Acknowledgement Of
Plans Submittal ONLY!
Date 6/19/13
Date 6/19/13

MAIN LEVEL

JOB ADDRESS:
Lots 10 & 11 in Riverwood Bend subdivision
Mooresville, NC 28117

SHEET NO. 3

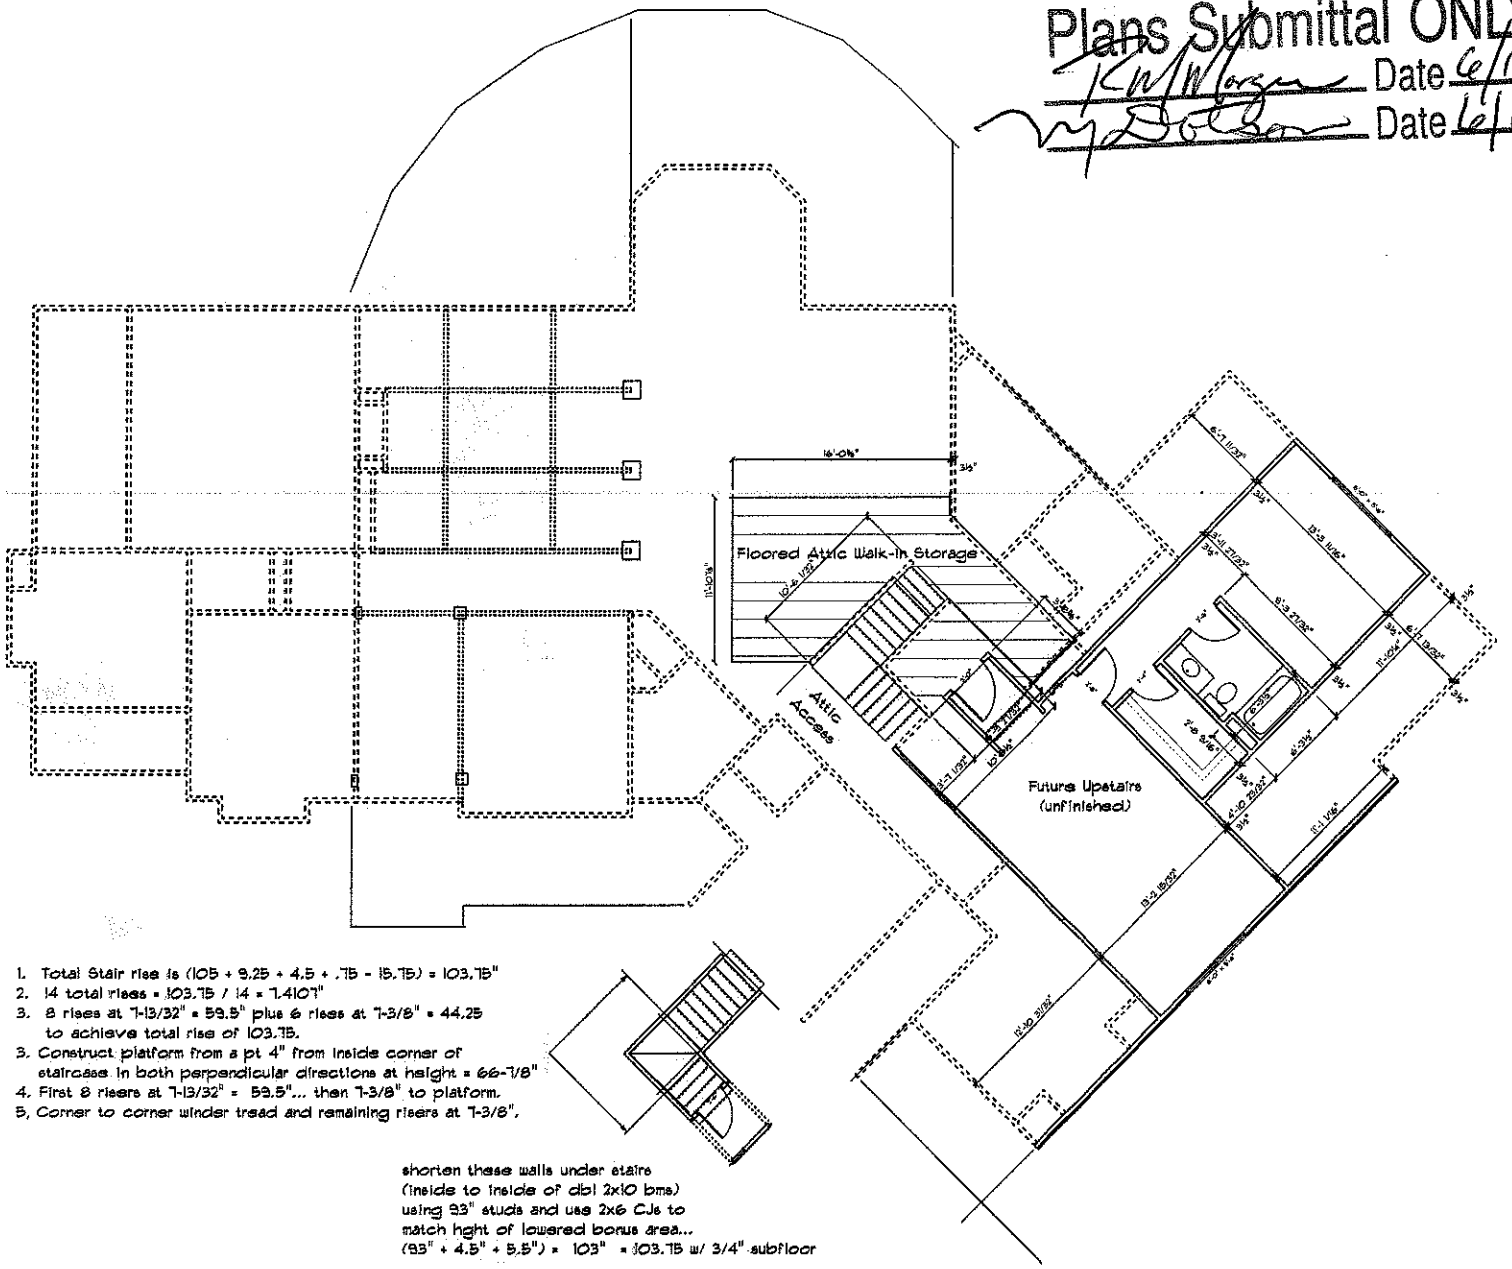
1. Total Stair rise is (105 + 9.25 + 4.5 + .75 - 15.75) = 103.75"
2. 14 total risers = 103.75 / 14 = 7.4107"
3. 8 risers at 7-13/32" = 59.5" plus 6 risers at 7-3/8" = 44.25 to achieve total rise of 103.75.
3. Construct platform from a pt 4" from inside corner of staircase in both perpendicular directions at height = 66-7/8"
4. First 8 risers at 7-13/32" = 59.5"... then 7-3/8" to platform.
5. Corner to corner winder tread and remaining risers at 7-3/8",

shorten these walls under stairs
(inside to inside of dbl 2x10 bms)
using 93" studs and use 2x6 CJs to
match hght of lowered bonus area...
(93" + 4.5" + 5.5") = 103" = 103.75 w/ 3/4" subfloor
